HIGHLANDS NORTH WEF, AMENDMENT APPLICATION: HERITAGE COMMENT
DEFF REF NO.: 14/12/16/3/3/1/1955

Thank you for providing the updated project information for the Highlands North Wind Energy Facility to be located between 19 km and 24 km west of Somerset East and to the south of the R63, Eastern Cape. It is noted that the proposed amendments relate largely to new technology which allows for larger turbines to be installed and battery storage to be incorporated.

Aerial view of the proposed Highlands North WEF showing the following:

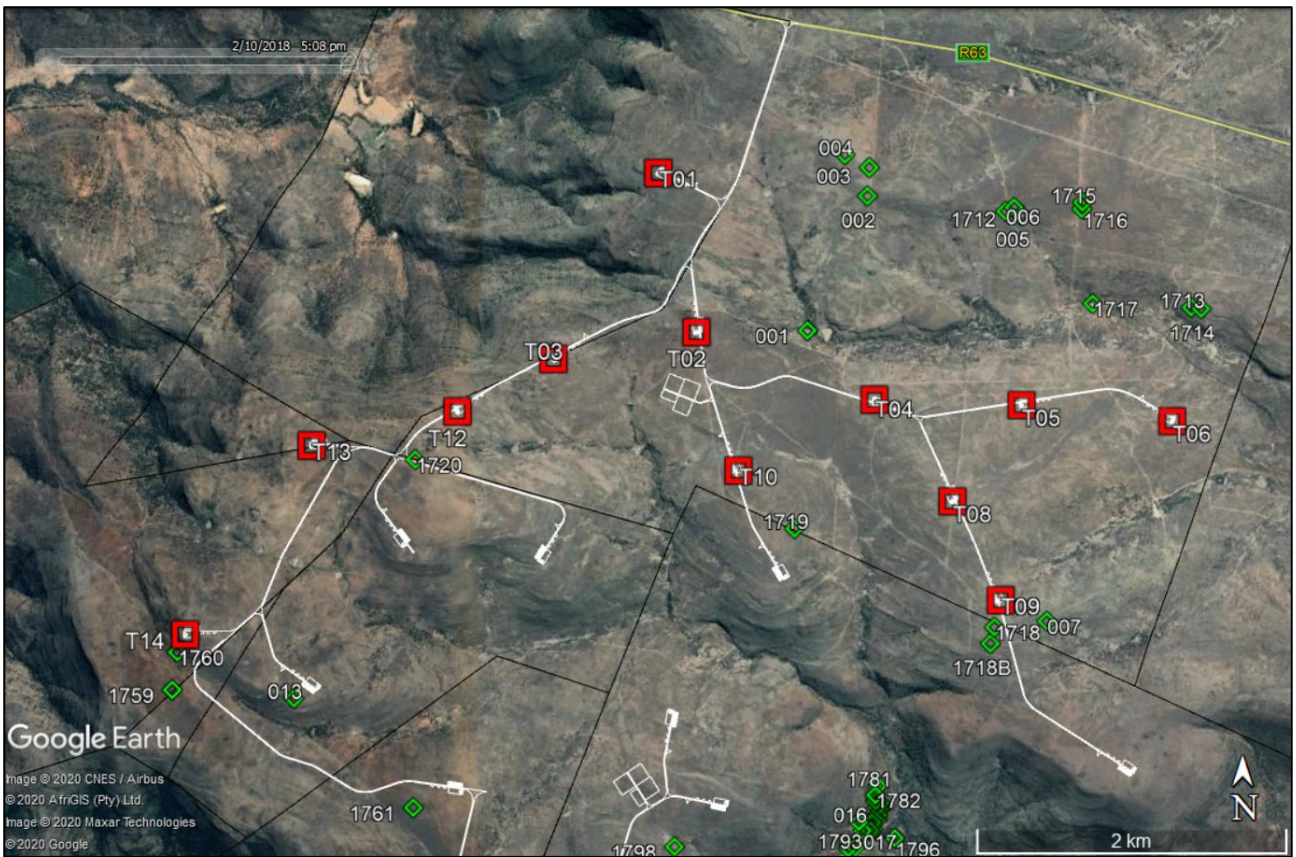
The proposed increase in size of these components could theoretically result in a higher likelihood of archaeological and palaeontological impacts occurring. However, it is noted that the original survey found very few significant sites and all of these have been avoided by the amended layout. Although a pre-construction survey is still required because the locations of archaeological and palaeontological sites is not fully predictable, the chances of impacts occurring are really little different to what they were before. All impact assessment ratings for both archaeology and palaeontology remain valid for the amended project. Note that potential impacts to graves were given the same significance ratings and these also remain the same for the amended project.

- There are no disadvantages to the proposed amended layout. In fact, there are two minor benefits in that (1) the overall footprint is decreased which means potentially fewer impacts to archaeological and palaeontological resources and (2) the reduction in turbines will very slightly reduce the visual intrusion of the facility in the cultural landscape.

Aerial view of the proposed Highlands North WEF showing the following:

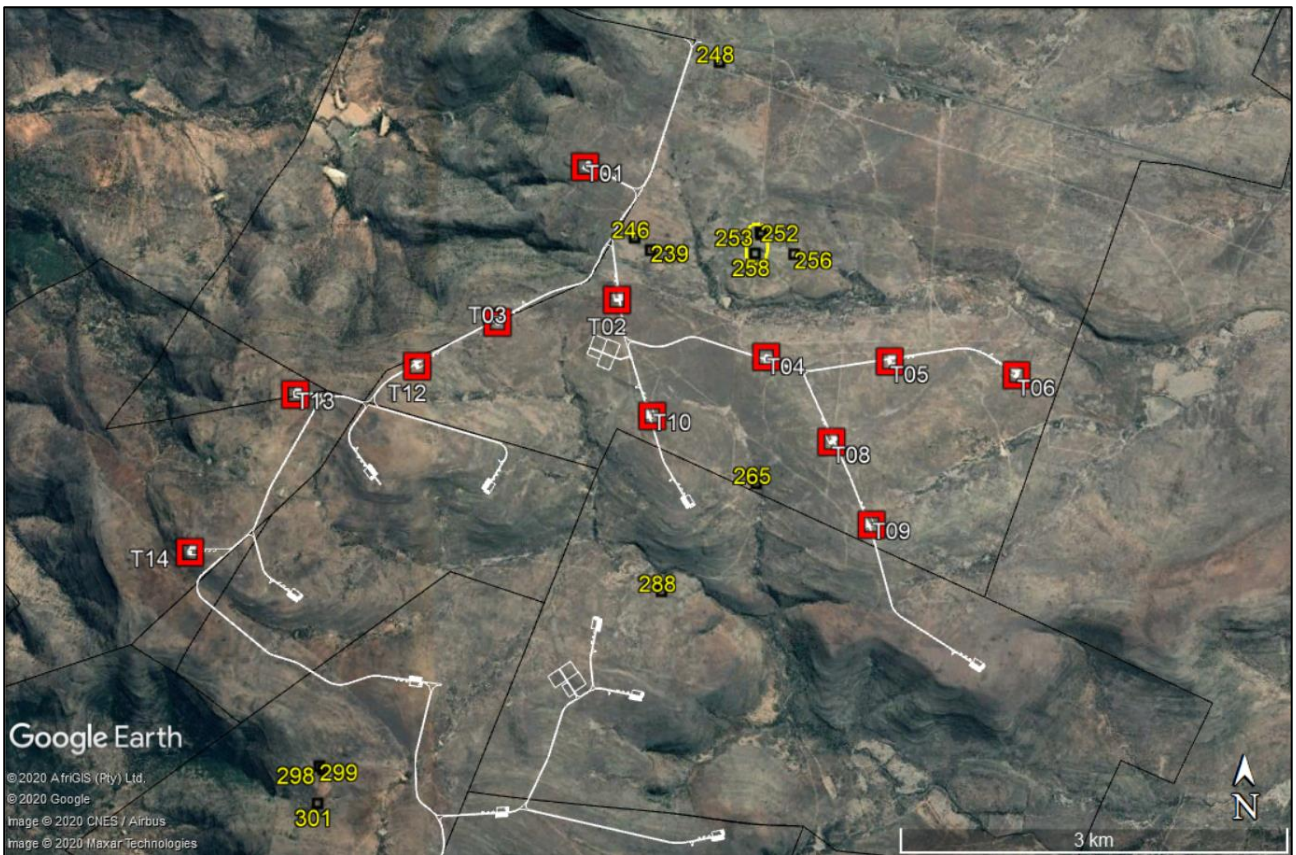
It is noted that the road length is reduced due to the smaller number of turbines proposed. The roads generally have the greatest chance of disturbing archaeological and palaeontological resources because of their large overall footprint. The decreased footprint will serve to offset the increased turbine footprint, but not to the degree that the assessed significance of potential impacts to archaeology and palaeontology would be reduced. The visual impact of the roads to the landscape is minimal because they are low to the ground and the facility is largely lower in elevation than the R63 which further reduces their visibility. The significance ratings thus remain as noted above.

Aerial view of the area in which the substation, offices, laydown areas and BESS would be located.

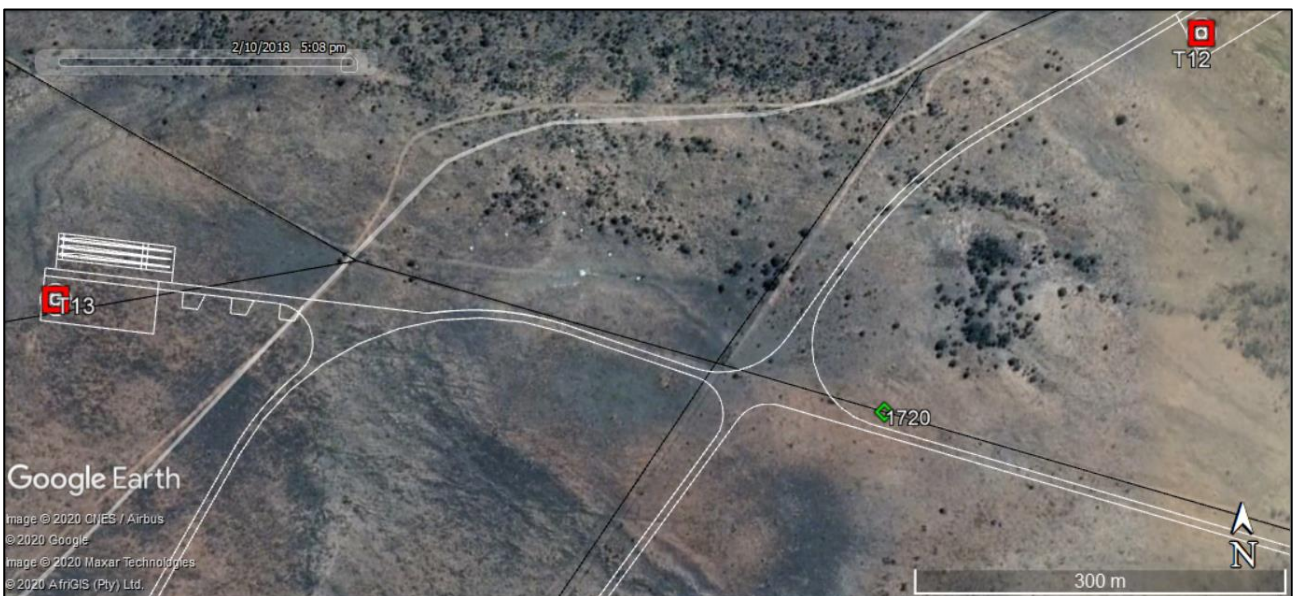
would not change, however, because the BESS is proposed to be located on the temporary laydown area. There would thus not be any new footprint to be disturbed. With regards to visual impacts, the BESS will be placed alongside the substation and operations/office area. This means that there would not be a new area with buildings. It is also relevant to note that the BESS would be located in front of the offices as seen from the R63 and some 2.3 km away from that road. The significance ratings thus remain as noted above.

Aerial view of the one heritage resource that will be minorly impacted. Waypoint 1720 is a fence line that incorporates historical stone fence posts. It will only be affected where the road intersection is located.
